Subject: **Palo Verde Nuclear Generating Station (PVNGS)
Units 1, 2, and 3
Docket Nos. STN 50-528, 50-529, and 50-530
APS Fifth 6-Month Status Report on the PVNGS Overall
Integrated Plan for Mitigation Strategies for Beyond-Design-
Basis External Events (Order Number EA-12-049)**

**APS Fifth 6-Month Status Report on the PVNGS Overall
Integrated Plan for Mitigation Strategies for
Beyond-Design-Basis External Events**

Figure 1

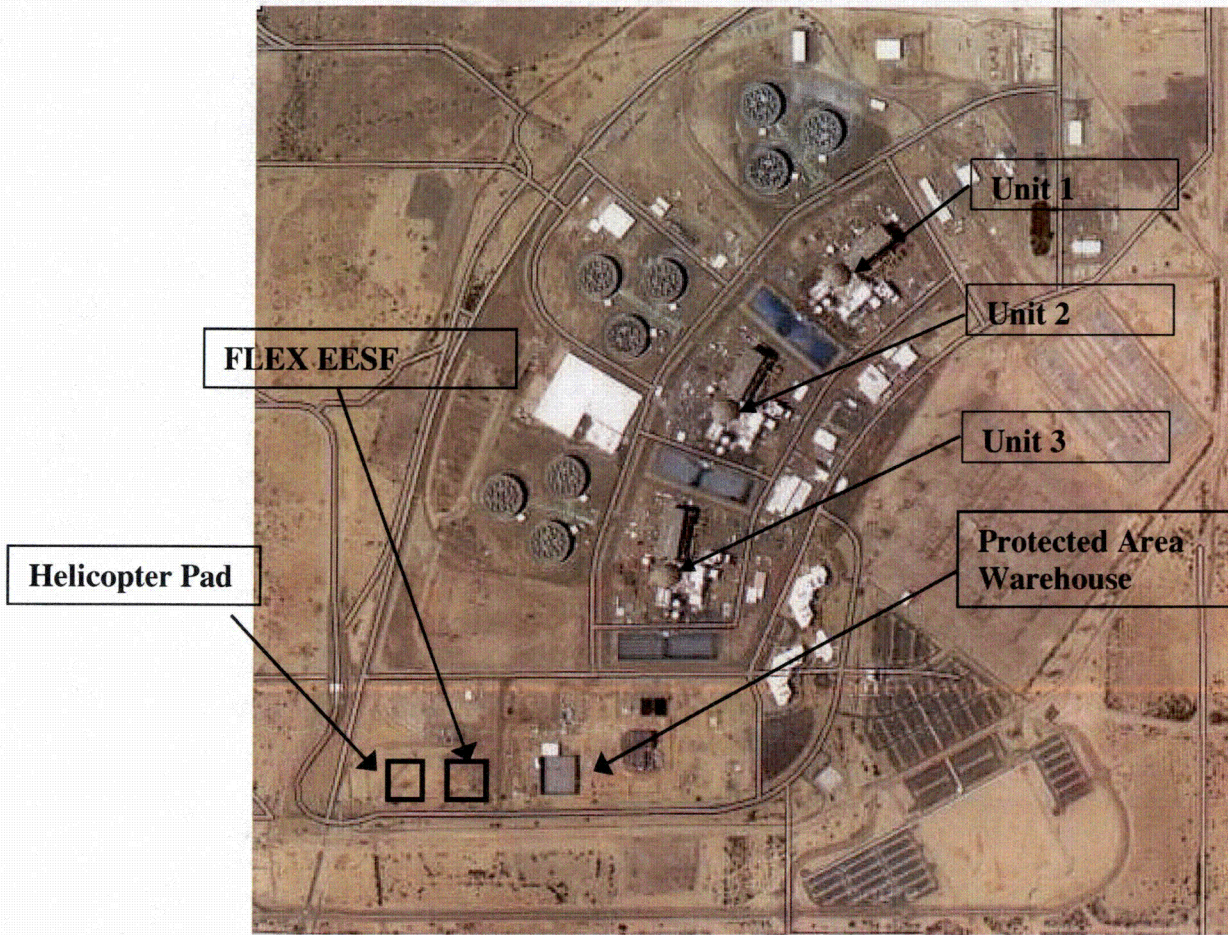
Overall Integrated Plan Open Items	Status
OI1- A storage location for FLEX equipment needs to be selected.	<p>Complete</p> <p>Location has been selected for FLEX equipment storage. The FLEX Emergency Equipment Storage Facility (EESF) will be located true west of the new Protected Area (PA) warehouse (outside of the PA but inside the Security Owner Controlled Area) and true east of the helicopter pad (See Section 9 Figure 1). Additional details on the locations of the temporary pad, FLEX EESF, and Helipad are included in Figure 2 (See Section 9 Figure 2).</p>
OI2- PVNGS FSG is currently a draft document and will need to be finalized. Existing site EOPs will need to be updated to direct use of the PVNGS Extended Loss of All Site AC Guideline during an ELAP. Additionally, a program and procedural control process is under development and will be implemented to meet the requirement of NEI 12-06 (Reference 3).	<p>Complete</p> <p>Activities have been completed as scheduled and noted, as applicable, on the Milestone Schedule Status Table in Section 3 of this enclosure.</p>
